WORKING SESSION MEMORANDUM

SUBJECT: **Petition #175-19 (2)**, for SPECIAL PERMIT/SITE PLAN APPROVAL to allow four single-family attached dwellings in ~~two~~ one buildings, to allow reduced side setbacks, to allow three-stories, to increase the allowed lot coverage, to decrease the minimum open space, to allow a driveway within ten feet of the side lot line and to allow retaining walls greater than 4' within a setback at 145 Warren Street, Ward 6, Newton Centre, on land known as Section 61 Block 39 Lot 10, containing approximately 23,399 sq. ft. of land in a district zoned MULTI RESIDENCE 1. Ref: Sec. 7.3.3, 7.4, 3.4.1, 3.2.4, 6.2.3.B.2, 5.4.2.B of Chapter 30 of the City of Newton Rev Zoning Ord, 2017.

145 Warren Street

Re: Special Permit – 145 Warren Street

Proposed Site Plan:

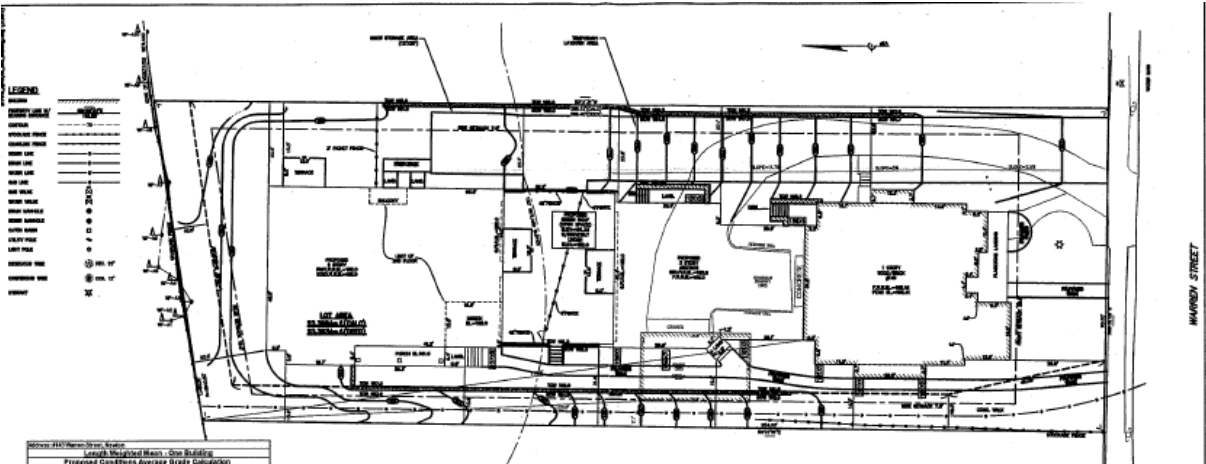
The proposed project maintains the existing side setbacks but does not comply with the required 25-foot setbacks for single family attached dwellings, requiring relief from the required setbacks. The proposed setbacks consist of a rear setback of 20.8 feet and a side setback of 14.4 feet from the western property line, which is also the existing setback. The side setback along the eastern property line is 23.5 feet.

The existing driveway is being extended in order to provide access to the lower level parking facility, which also requires relief for being within ten feet of the side lot line. There is also an extension of the driveway beyond the entrance to the garage that is to be used for snow storage. The petitioner is planning to reduce the driveway in order to increase proposed open space, currently calculated at 49.9%, where 50% is the minimum allowed. The Planning Department recommends that the petitioner comply with the open space requirement of 50%.

Due to the historic structure and efforts to complement the existing structure, the design is lower and wider in scale, therefore requiring relief to increase allowed lot coverage from 12.9% to 37.6% where 25% is the maximum allowed.

The proposed retaining wall along the western property line gradually increases in height from the front of the site to the rear. The beginning of the wall at the front of the site is ½ foot, and gradually increases to a height of four feet towards the rear of the site. The proposed retaining wall at the eastern property line starts off at 1.3 feet and reaches a maximum of height of six feet toward the middle of the site and declines to a height of

The Planning Department views the proposed project as an exception to the literal compliance with dimensional standards due to the design of the structure maintaining and incorporating the existing historical structure. The setbacks that require relief are well screened with landscaping and the rear of the site abuts the MBTA green line tracks and encroaching into the rear setback will have little to no impact on the surrounding neighborhood.

Elevations:

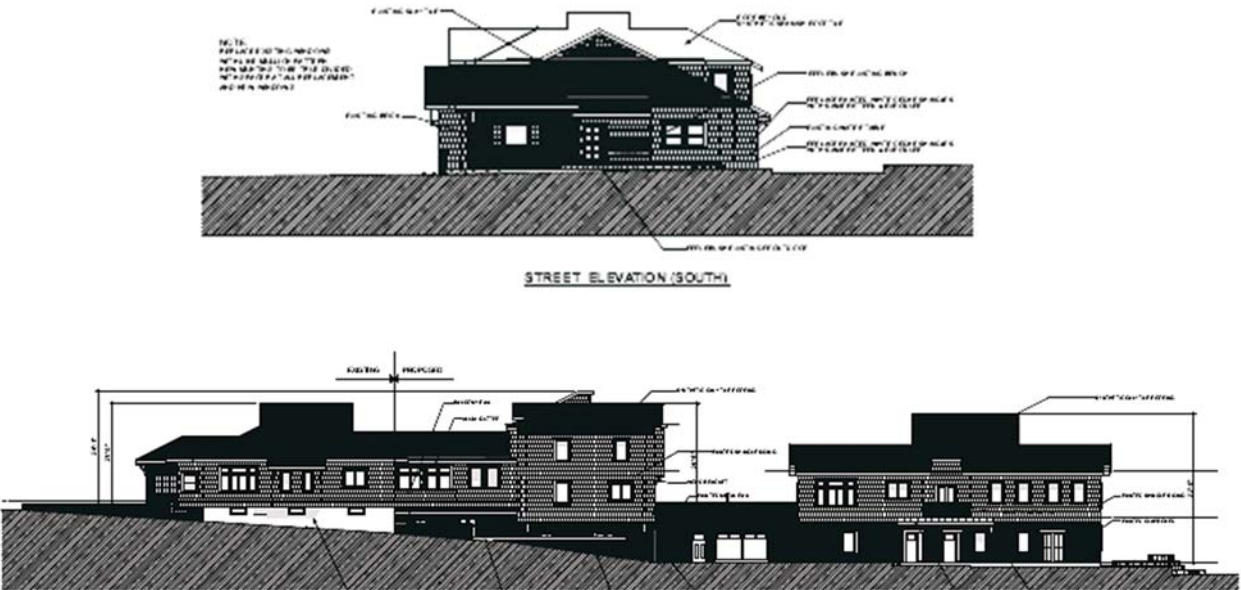
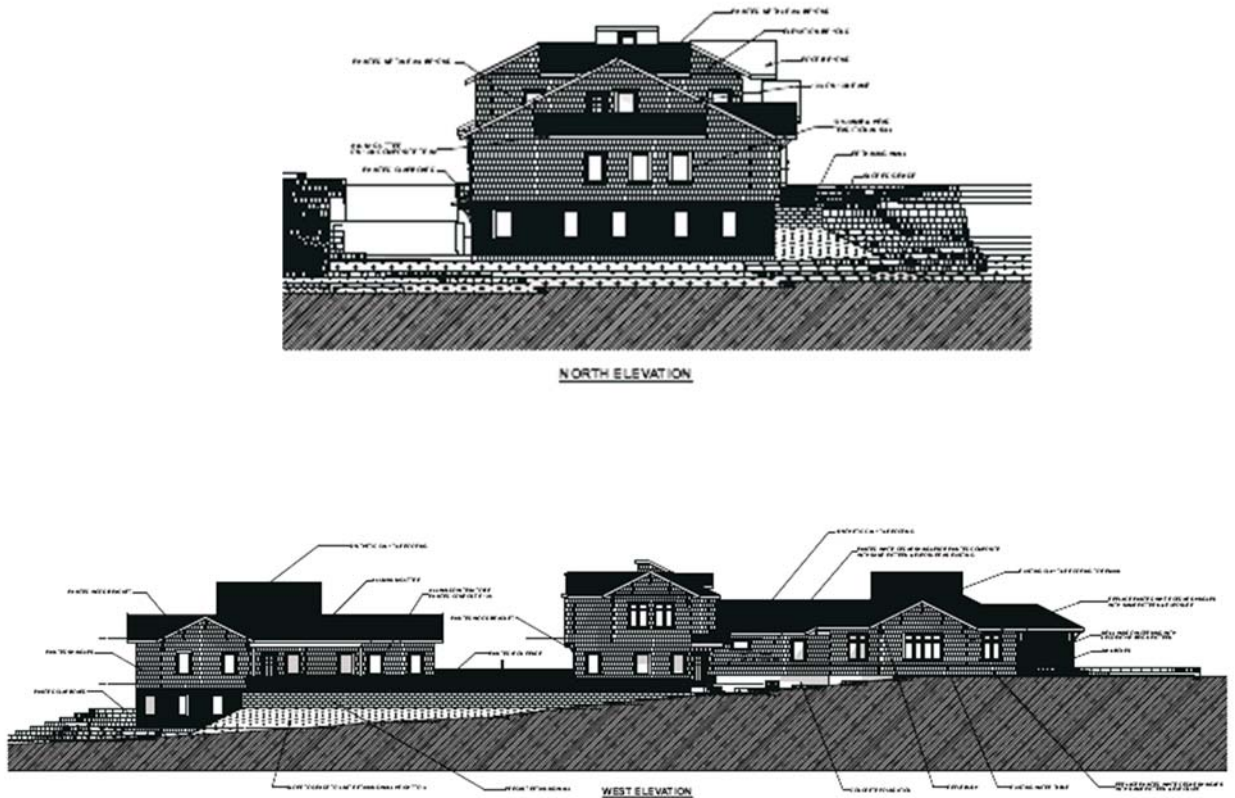
In so far that the structure is considered one structure bisected by the green roof, the height of the building is 32.36 feet. This is under the 36 feet that is allowed in the MR-1 zone.

The Planning Department is unconcerned with the request to allow single-family attached dwellings that requires dimensional relief. The design was carefully considered to incorporate the existing historic structure which resulted in a lower, wider design that requires a reduction from the required side and rear setbacks.

*Topographic Site Plan
Showing Proposed Conditions at
#145 Warren Street
Newton, MA
Prepared by: VTP Associates Inc.
Dated: April 1, 2019*

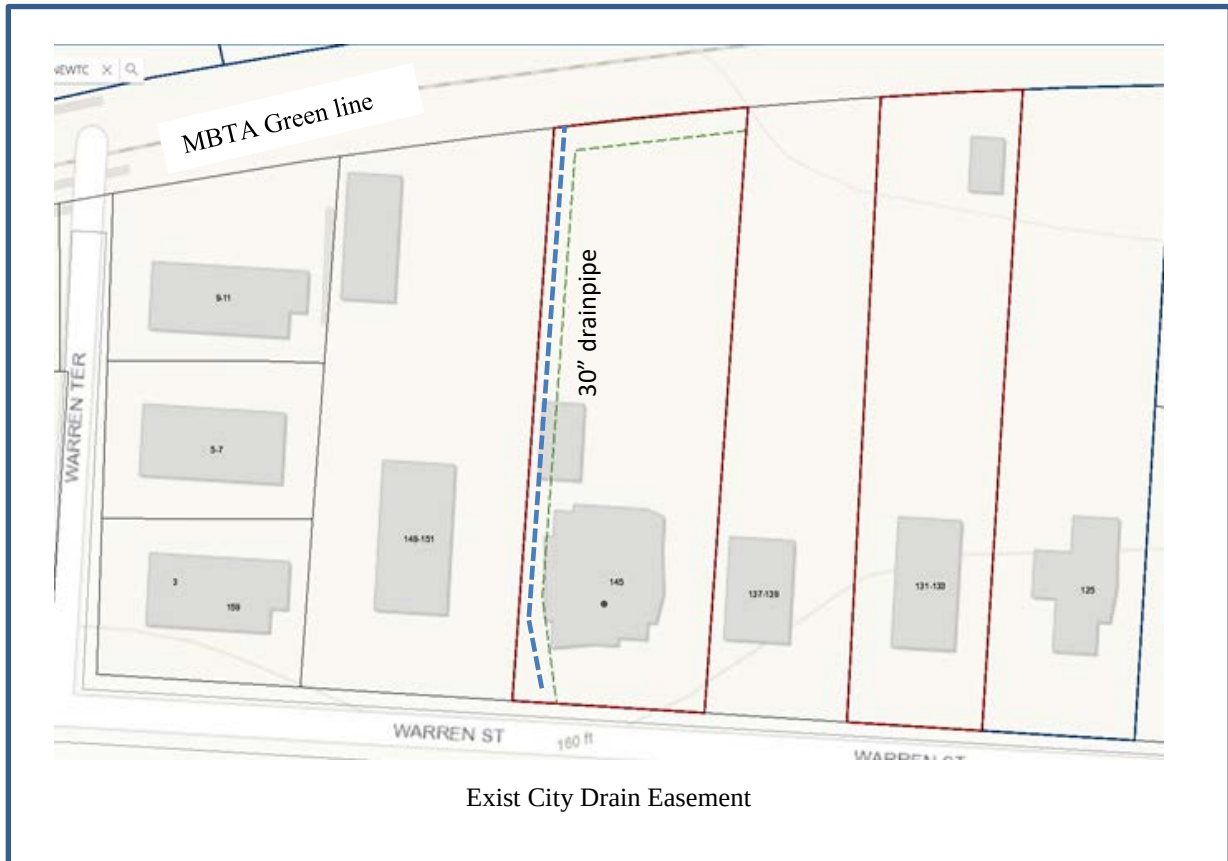
This application entails the demolition of a circa 1930 single-family dwelling and the construction of a three-unit residential development. The property has 22,383 square feet [0.51 acres] with 90 feet of frontage along Warren Street. The site is bound by residential homes on the east & west, Warren Street to the south and the MBTA green line along its northern border. The site has a high point at elevation of 163-feet near Warren Street and slopes down towards the north near the MBTA tracks at elevation of 149-feet.

Access to the units, garages and auto court is provided via driveway located near the easterly property line. The driveway has a retaining wall directly on the property line for a distance of +/- 65-feet and is 6-feet at the high point; the construction of the wall may encroach the neighboring property. It is recommended that the wall be pulled back 1-2 feet to avoid any potential of encroachment. Retaining walls over 4 feet high will need a structural engineers design to ensure that the wall does not fail in (overturning, sliding or settlement) along with a safety fence along the top of the wall.

A City Drain Main easement traverses the property along the north and west property lines, a 30-inch drainpipe transmits stormwater from the road collection system through the lot and into the wetlands along the MBTA. The design has a proposed retaining wall located within the drainage easement, should this application be approved, a license agreement will be required for the construction and long-term maintenance of this wall; pre & post construction inspection of the 30" drain pipe via a closed circuit television (CCTV) will be required and should be part of any Board Order.

The engineer of record has designed a drainage collection system consistent with the DPW Stormwater Management Policy that collects and infiltrates the 100-year storm event on site. The design includes four infiltration systems for infiltration of roof and driveway runoff.

System #2 is located along the western property line, my concern with the siting of this is the proposed location and long-term maintenance requirement. The Operations and Maintenance [O&M] plan indicates that the system needs to be inspected and cleaned, however; access to this system is difficult at best as it is placed behind the dwelling units and near the drainage easement, there is no easy access to clean the system. I recommend that this proposed infiltration system be located within the proposed auto-court for easier access. The O&M plan does not include any provisions for bi-annual sweeping of the driveway and auto court, this is needed as it impacts the long-term performance of the infiltration systems.

Municipal utilities will be provided for the three units, additionally the sanitary sewer services will require individual pump systems. The design should incorporate a standby generator for these systems in the event of prolonged power outages since these systems do not have a large storage capacity.

As a public benefit the sidewalk should be upgrade to City Standards to include cement concrete sidewalk, driveway apron and granite curbing along its entire frontage.
